Addendum No. 4

To: International Buddhist Progress Society of Ottawa - Carleton
From: Egis Group Ltd. (formerly McIntosh Perry Consulting Engineers Ltd.)
Date: January 21, 2025
Re: Additional Technical Information to the Revised Geotechnical Report Issued January 2019—
IBPS - 6688 Franktown Rd Richmond

This is an addendum to the revised Geotechnical Report, dated January 2019, which is included in Appendix E. It provides updated recommendations for the foundation design of the proposed temple building, based on the new architectural and civil drawings provided by the International Buddhist Progress Society of Ottawa (the client), which reflect the building's relocation. This addendum must be read in conjunction with the revised report. The additional information and recommendations are presented below. The included information does not replace that which already exists in the revised January 2019 report but serves to augment or update as necessary.

PROJECT No.	OTT-22027645-AD
SURVEY	MEINTOSH PERRY
DATE	25/08/23
DRAWING No.	C200

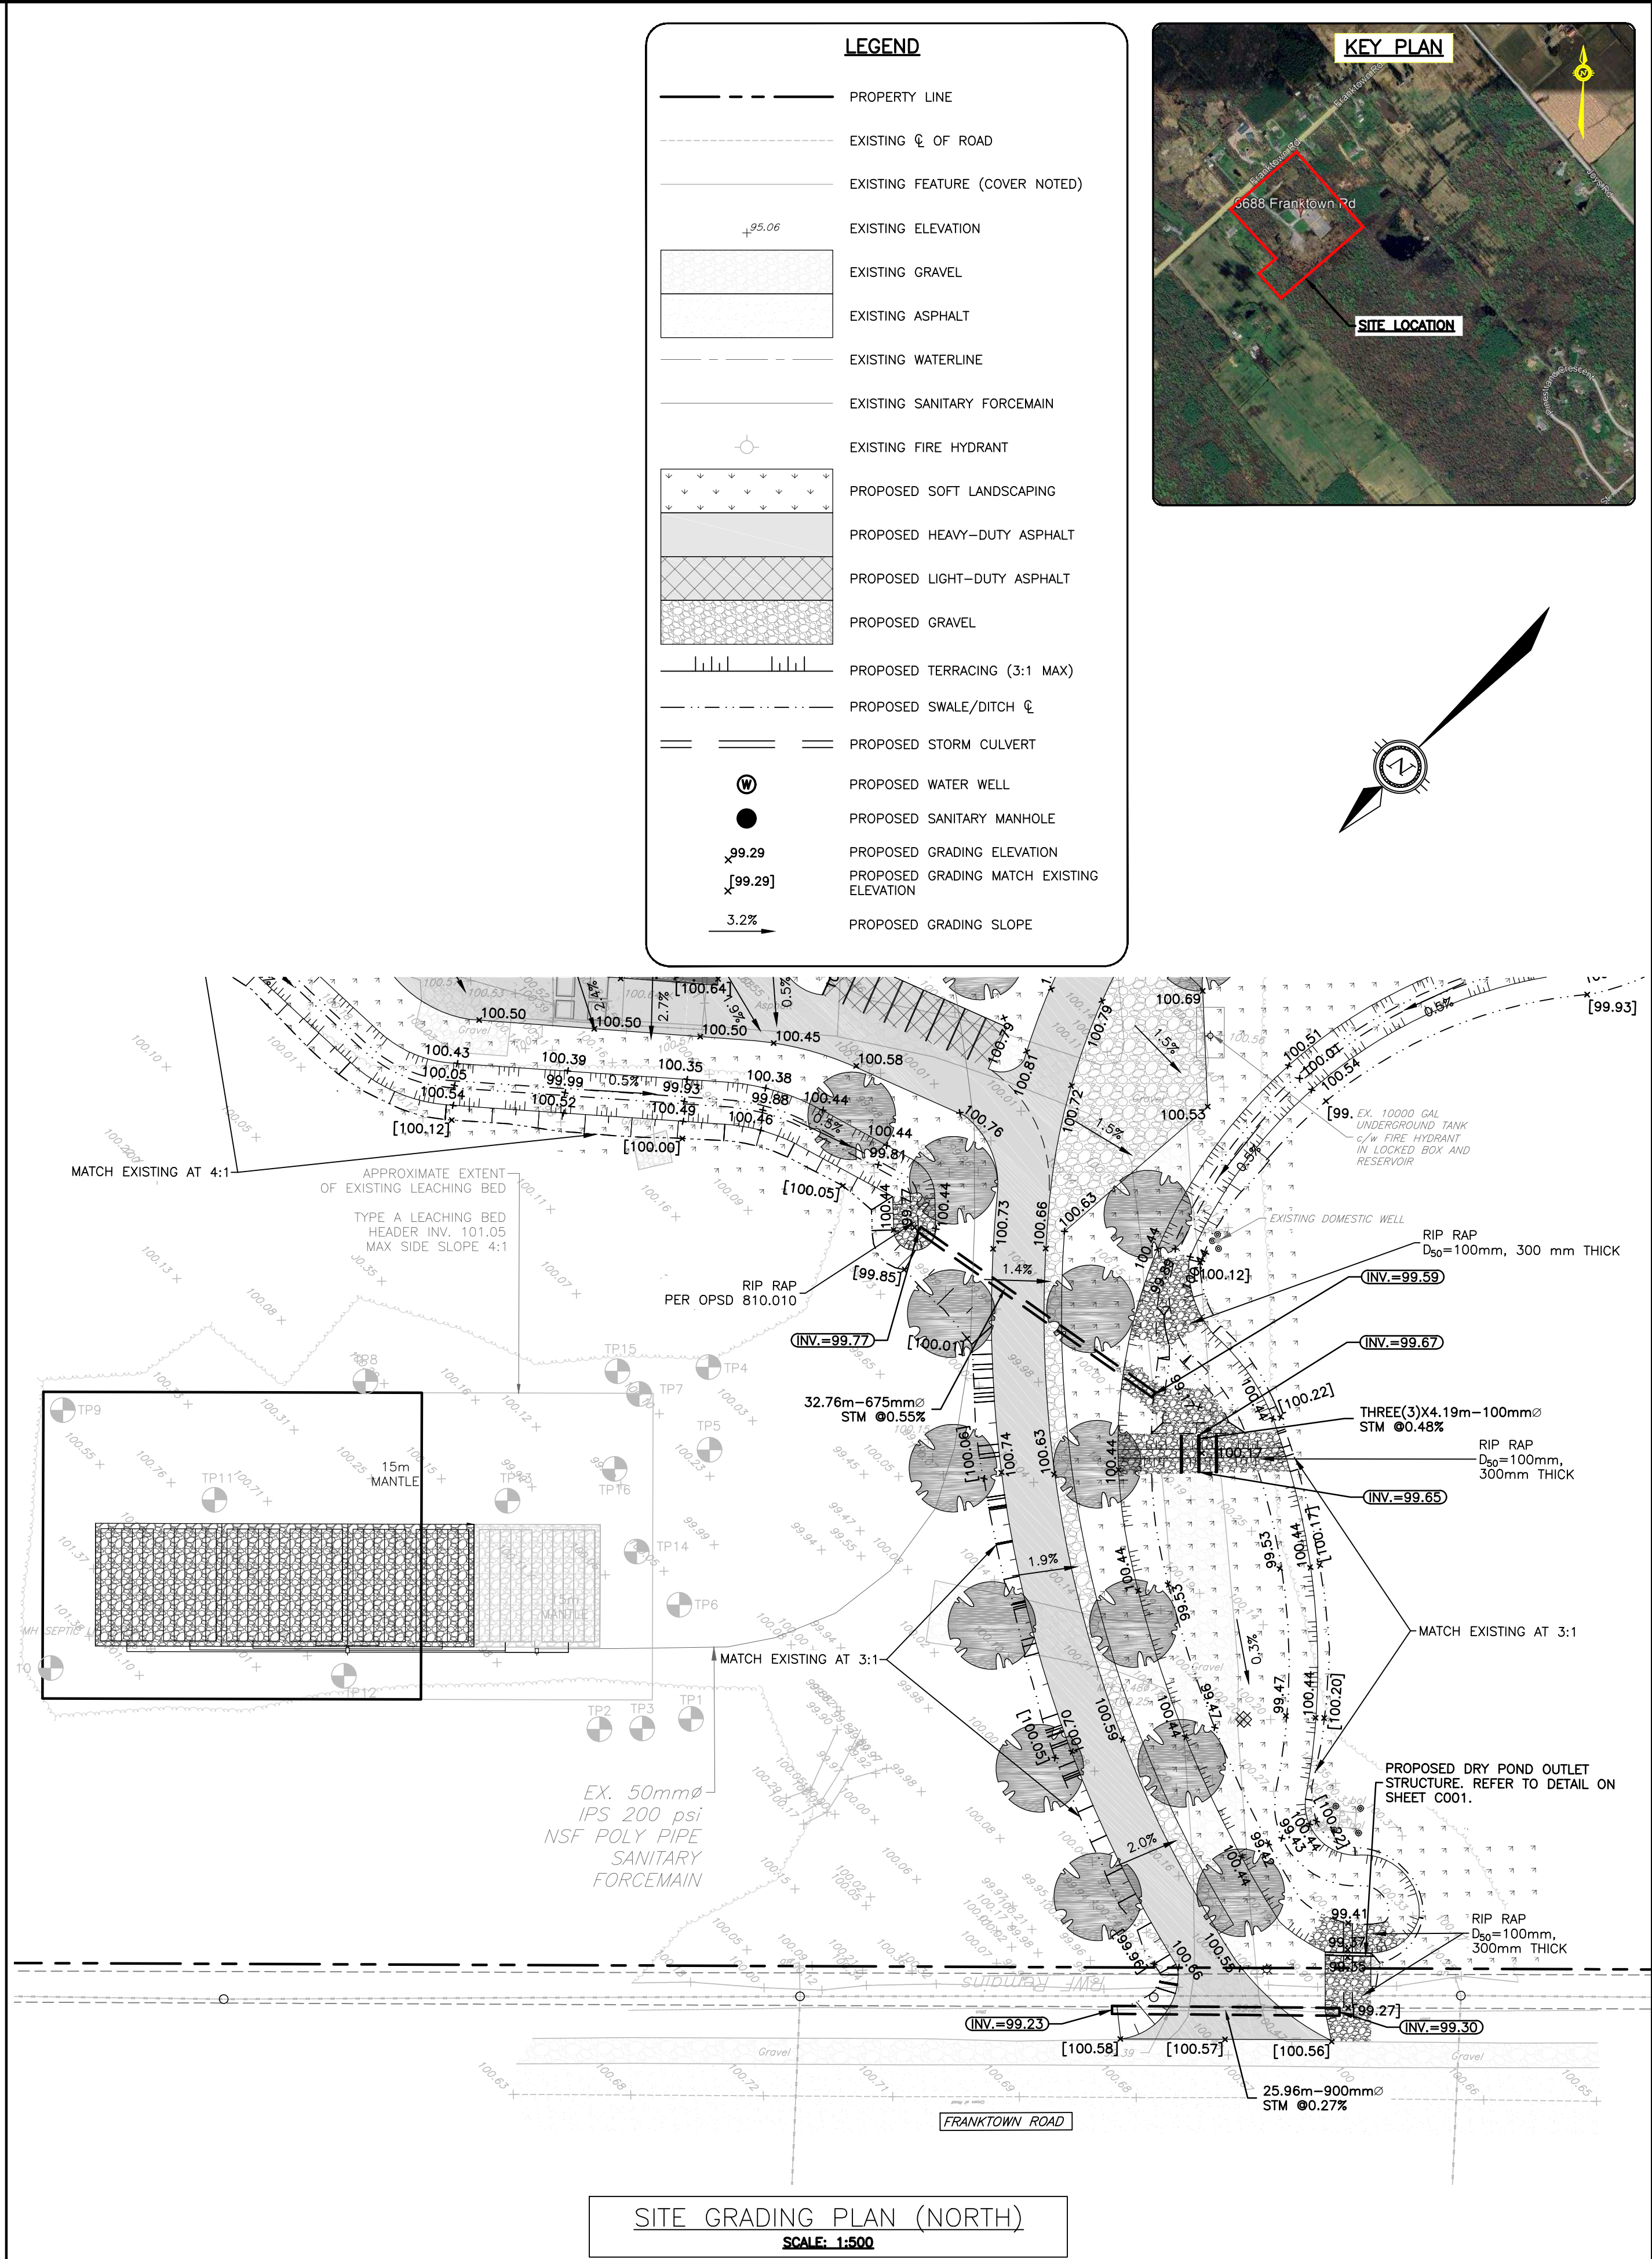
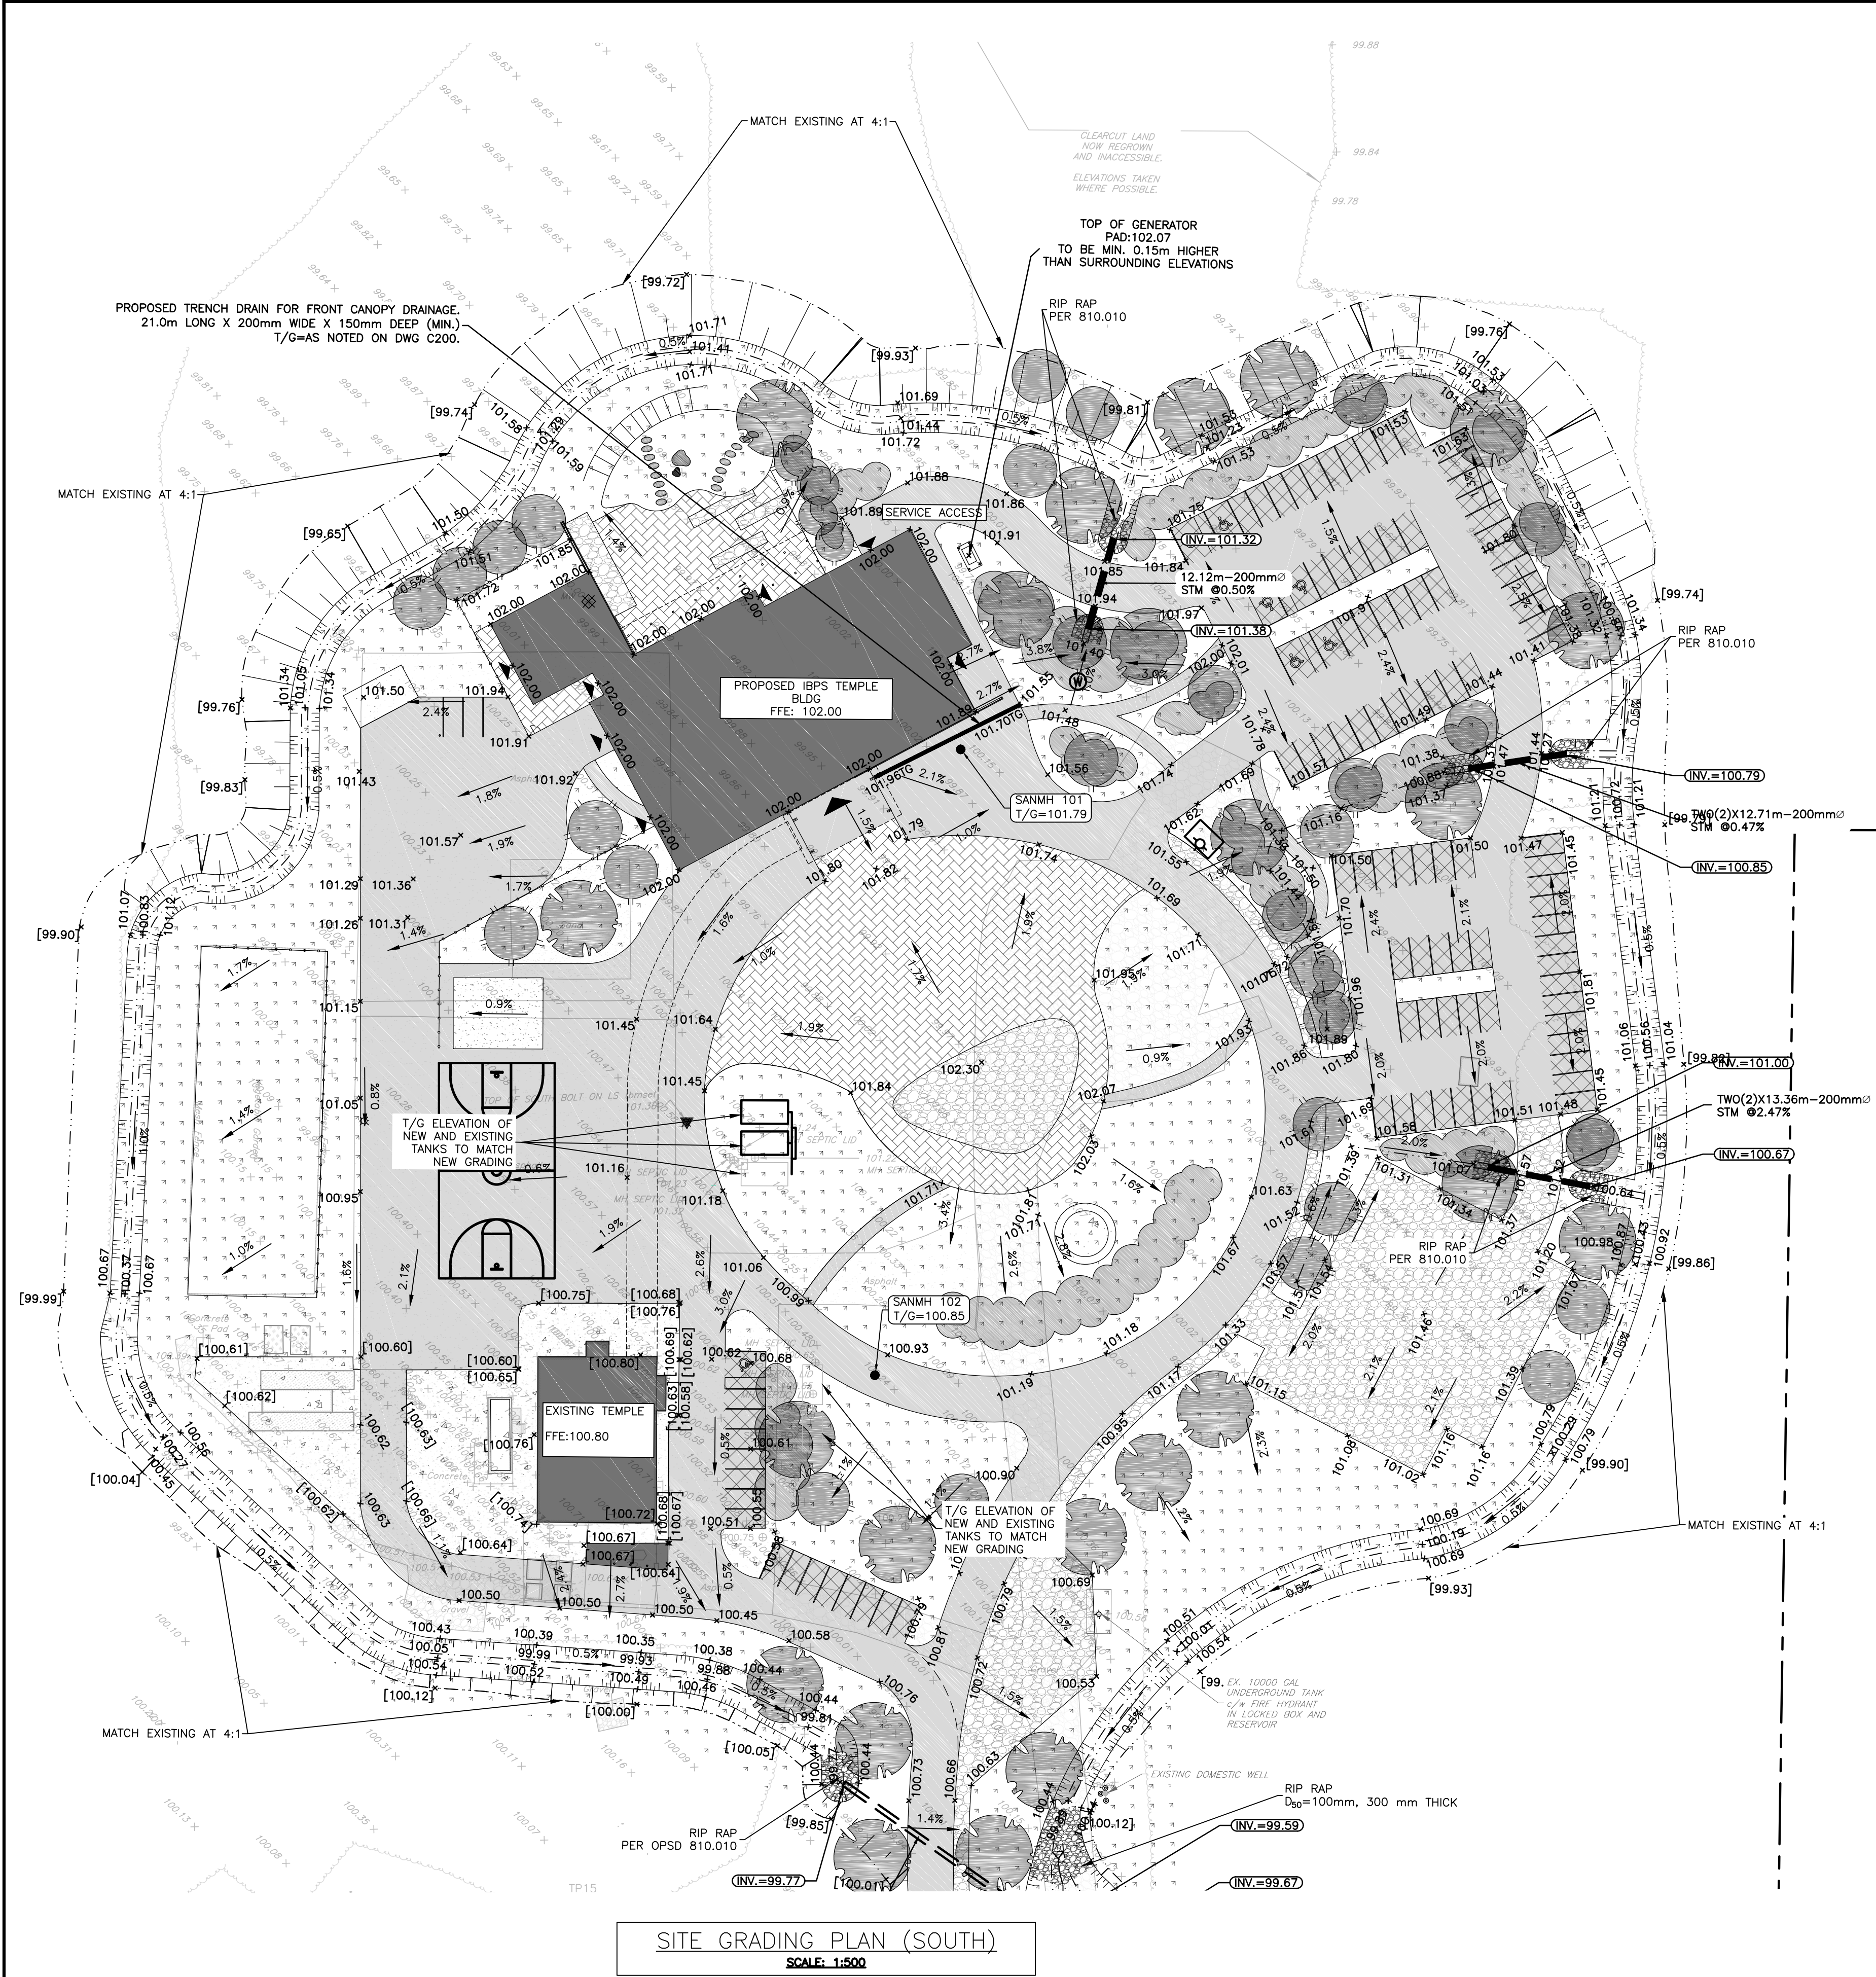
- According to the site grading plan titled C200 Rev. 04 (included in Appendix C), prepared by EXP Services Inc., dated December 18, 2024, provided by the client, the Finish Floor Elevation is set at 102 m asl. The existing site grades beneath the building footprint range from 99.82 m to 100.02 m asl, indicating a grade raise of approximately 2.0 m.
